MILWAUKEE RIVER ADVISORY COMMITTEE

TO: Milwaukee River Advisory Committee
FROM: Justin Bodoh, Building & Grounds Superintendent
DATE: October 6, 2025
SUBJECT: Update on FEMA Floodplain Plan

City of Mequon FEMA Floodplain Mapping Review
M Squared Engineering
February 28, 2025

Figure 1. HEC-RAS Cross-Section of Pioneer Road over the Milwaukee River

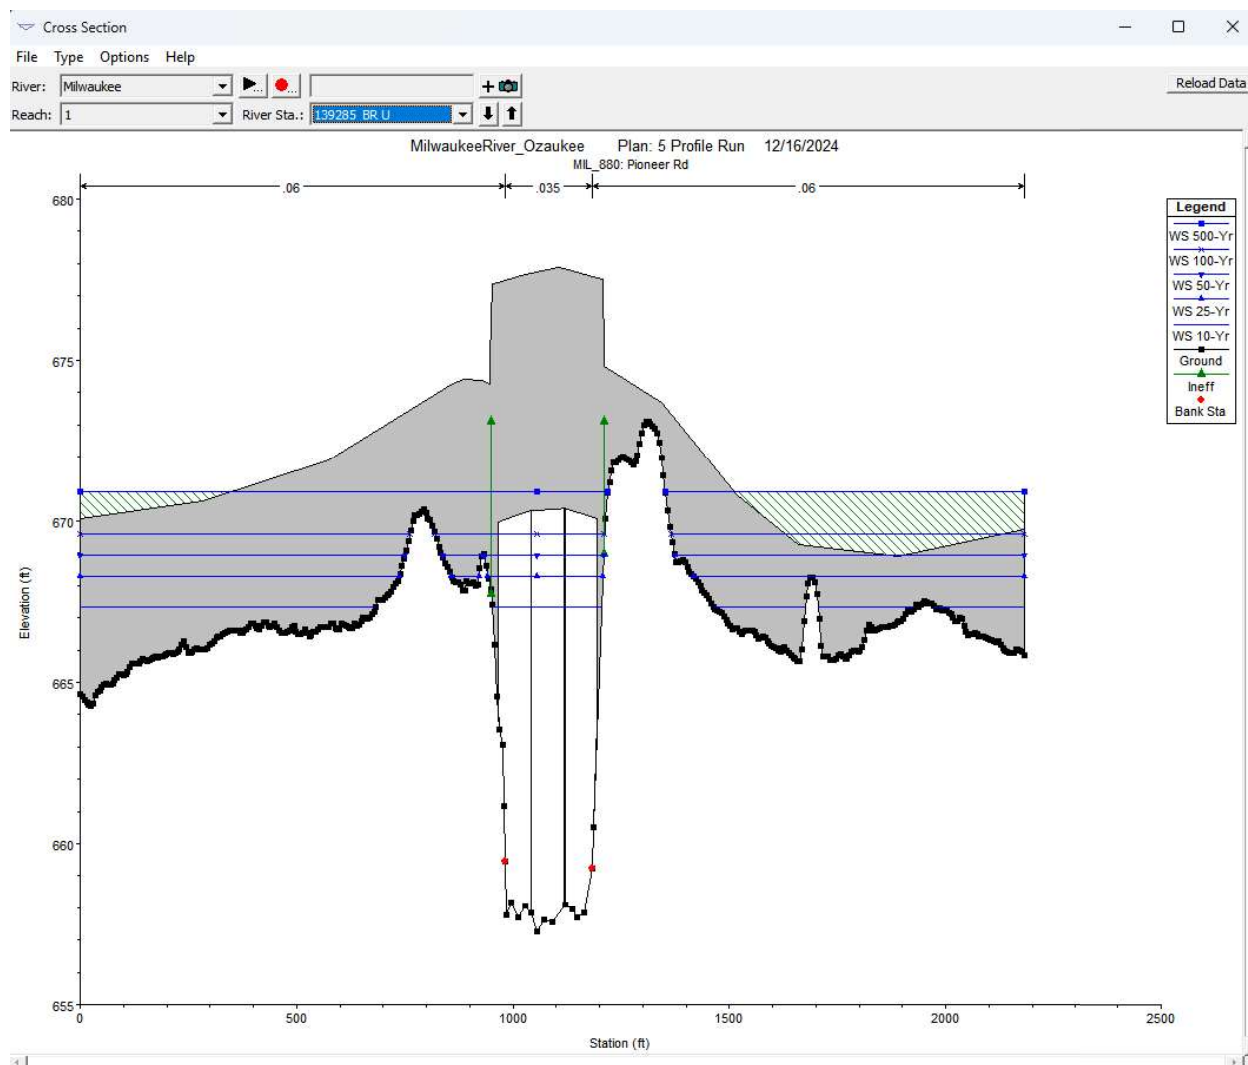
Ineffective flow areas are used in hydraulic modeling to indicate an area of inundation of flood waters, but not an area that is conveying active flow. For example, this could be used to delineate ponded water behind a roadway embankment where the water is not actively flowing. The ineffective flow locations in the HEC-RAS model seem somewhat random and do not have elevations associated with them. In the model, Pioneer Road, Highland Road, and Mequon Road all experience overtopping, but due to the way ineffective flow has been used in the model this

conveyance is not being recognized properly. Ineffective flow removes capacity from the floodplain and typically increases the height of the water surface elevations. If the overtopping was modeled more accurately, it is possible the water surface elevations could decrease at these crossings. Figure 1 shows the cross-section at Pioneer Road where overtopping is shown but is marked as ineffective flow.

Figure 3. HEC-RAS Cross-section showing LOB not containing the water surface elevations

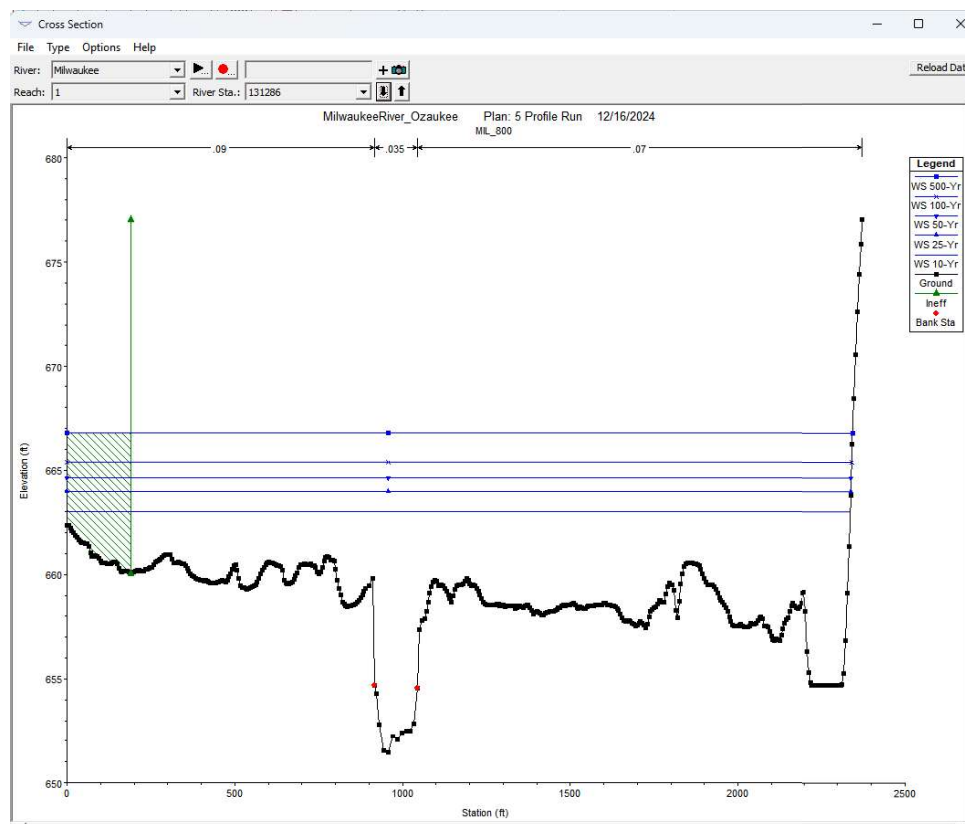
Several cross sections have computed water surface elevations above the far left and right stations. This results in "The cross-section end points had to be extended vertically for the computed water surface" errors. Either these cross sections need to be extended with additional survey data or computer water surface elevations should be below the cross-section end points. Figure 3 shows an example of a cross-section where the left overbank (LOB) does not extend far enough to contain the water surface elevations.

Figure 4. HEC-RAS Cross-section ineffective flow and floodway encroachments

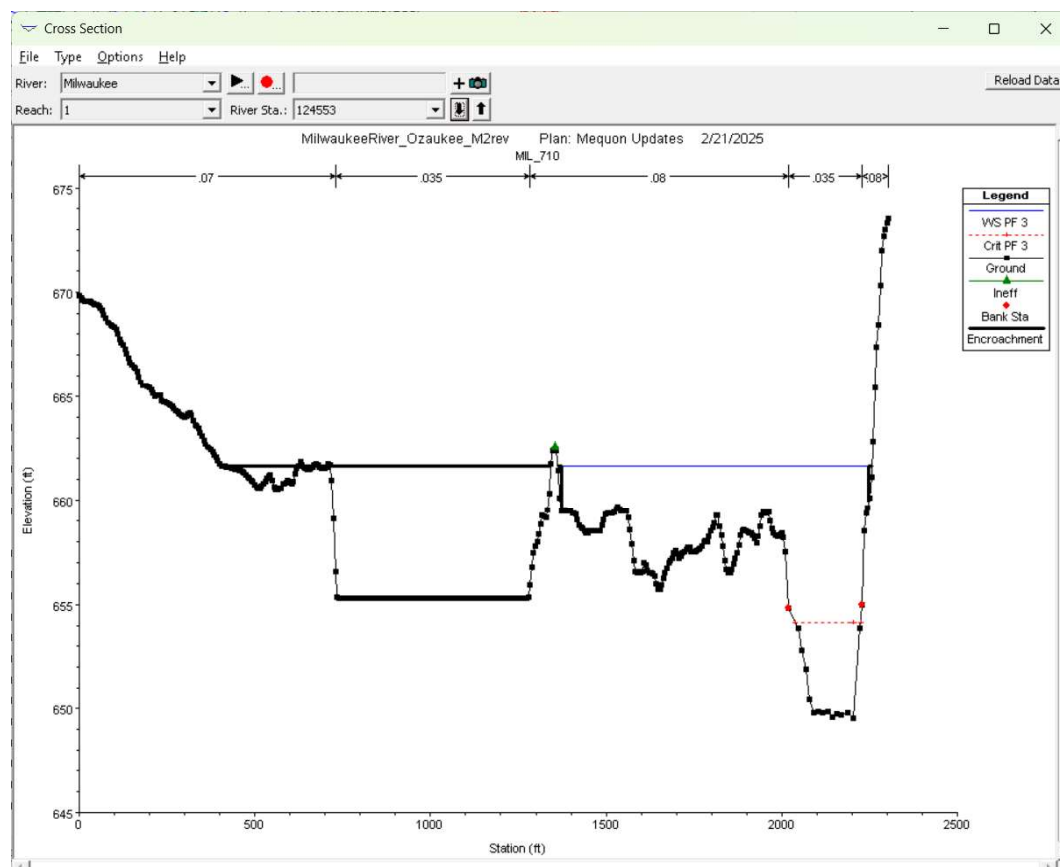
Floodway encroachments changed appropriately with the modeling effort. Ineffective flows were added where elevations were not inundated until overtopped. Permanent ineffective flows were also added as appropriate. The test for ineffective flow is, “Does it get wet?” and “Does it flow?” The answer should be YES, it does get wet, and NO it does not flow to meet permanent ineffective flow criteria. This modified the floodway limits from the FEMA maps and generally were narrower. A typical reduction is shown below. The heavy black line on the left shows the floodway encroachment just beyond the small green triangle that represents ineffective flow. In the cross section below the floodway limits are approximately half of the floodplain limits. However, it is

important to note that encroachment limits varied along the Milwaukee River and were highly dependent on channel geometry and resultant water surface elevations.

Figure 5. HEC-RAS Trinity Creek 100-year profile plot

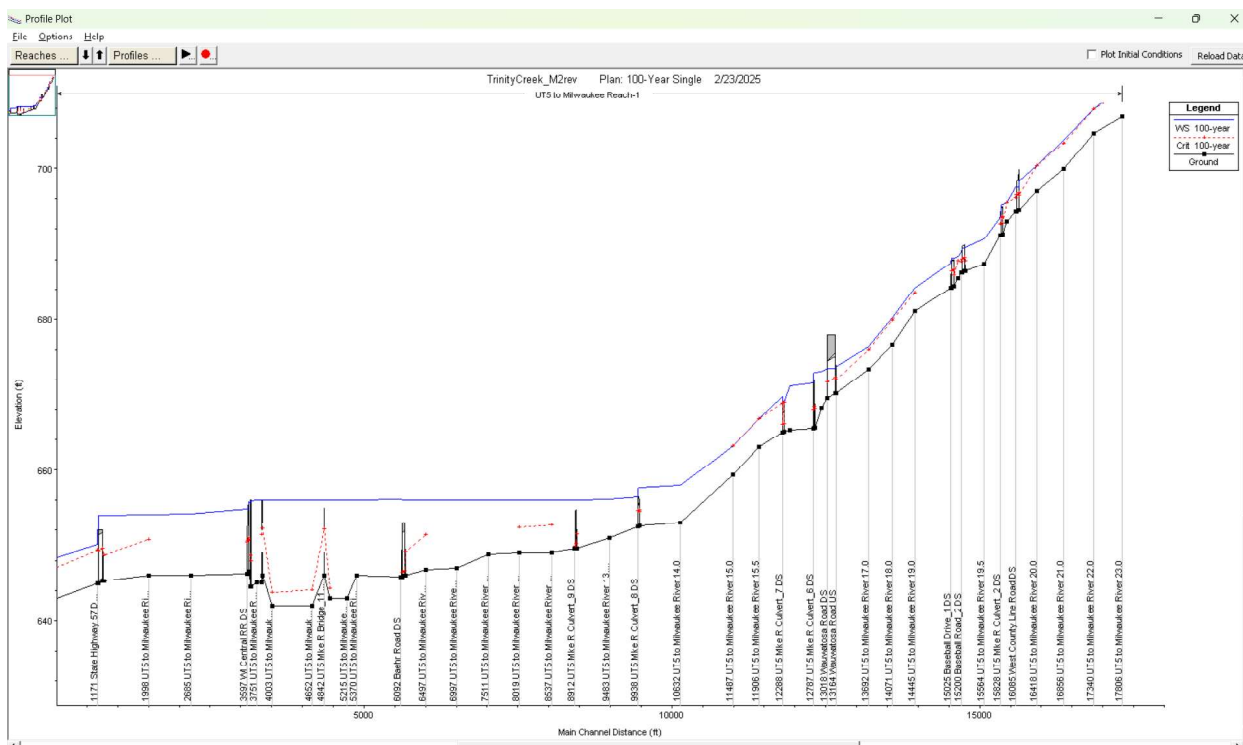
The Milwaukee River has a published backwater condition on Trinity Creek of 655.1. M Squared computed lower water surface elevations of 653.5, a little over 1.5-feet lower. Projecting the Milwaukee River elevation of 653.5 into Trinity Creek only impacts the section from State Highway 57 downstream to the confluence. Upstream of State Highway 57 to the Central Wisconsin Railroad water surface elevations reduced from the FEMA elevations of 655.6 to 655.8 about one to one and a half feet to 654 to 654.9.

Upstream of the Central Wisconsin Railroad computed water surfaces reduced about one foot compared to the FEMA published results to 656 from 657.1. The end of this area corresponds to

FEMA cross section F and results upstream were similar between the FEMA and M Squared models.

Upon completion of the Trinity Creek modeling M Squared suggests the following recommended changes to the HEC-RAS modeling.

The Milwaukee River backwater condition will result in a lower computed water surface elevation for Trinity Creek from the confluence with the Milwaukee River to FEMA cross section F. This elevation reduction also corresponds with a narrower floodway encroachment. Due to the stringent floodway encroachments for the State of Wisconsin the floodway limits are very close to the floodplain limits. Therefore, there will not be a significant reduction in floodway limits beyond the water surface elevation reductions.
